McCULLOCH SERVICE BULLETIN

NO. 1594

MODEL Large Direct Drive Saws (SP125, SP105 & 795 Series) DATE December 24, 1975

SUBJECT Bar Spacer Plates Kit, P/N 92020.

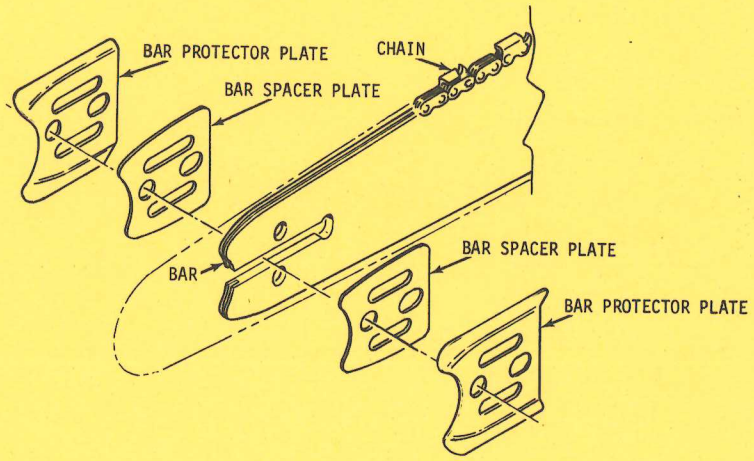
The new "Speed-Mac" guide bars, P/N 91300, 91301, 91324, and 91336 will require spacer plates if they are used in conjunction with Bar Plates on the large direct drive saws listed above.

To ensure adequate clearance between the chain and the bar protector plates, install the bar spacer plates between the bar and protector plate, as shown in the figure below.

NOTE: Be sure spacers are <u>between</u> bar and protector plates.

Kit, P/N 92020 and instructions are packaged with each "Speed Mac" guide bar listed above.
